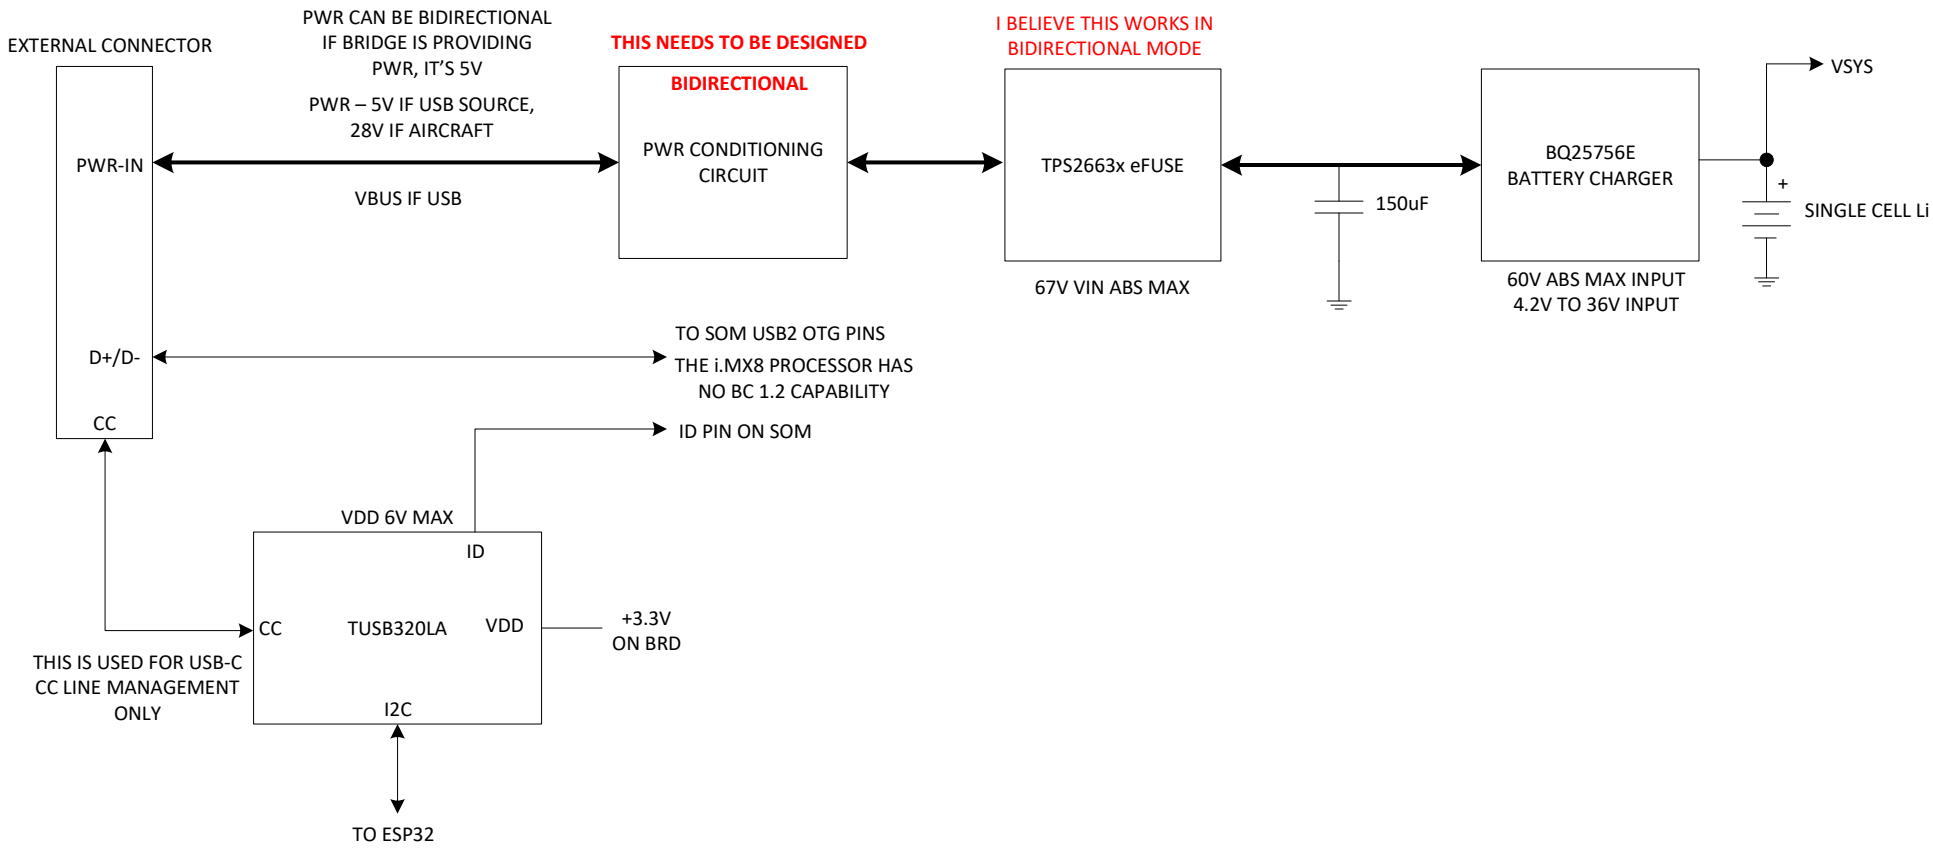
EXTERNAL CONNECTOR
PWR CAN BE BIDIRECTIONAL
IF BRIDGE IS PROVIDING
PWR, IT'S 5V
THIS NEEDS TO BE DESIGNED
BIDIRECTIONAL
I BELIEVE THIS WORKS IN
BIDIRECTIONAL MODE
VSYS
PWR – 5V IF USB SOURCE,
28V IF AIRCRAFT
PWR-IN
PWR CONDITIONING
CIRCUIT
TPS2663x eFUSE
BQ25756E
BATTERY CHARGER
VBUS IF USB
150uF
SINGLE CELL Li
67V VIN ABS MAX
60V ABS MAX INPUT
4.2V TO 36V INPUT
TO SOM USB2 OTG PINS
D+/D-
THE i.MX8 PROCESSOR HAS
NO BC 1.2 CAPABILITY
CC
ID PIN ON SOM
VDD 6V MAX
ID
CC
TUSB320LA
VDD
+3.3V
ON BRD
THIS IS USED FOR USB-C
CC LINE MANAGEMENT
ONLY
I2C
TO ESP32
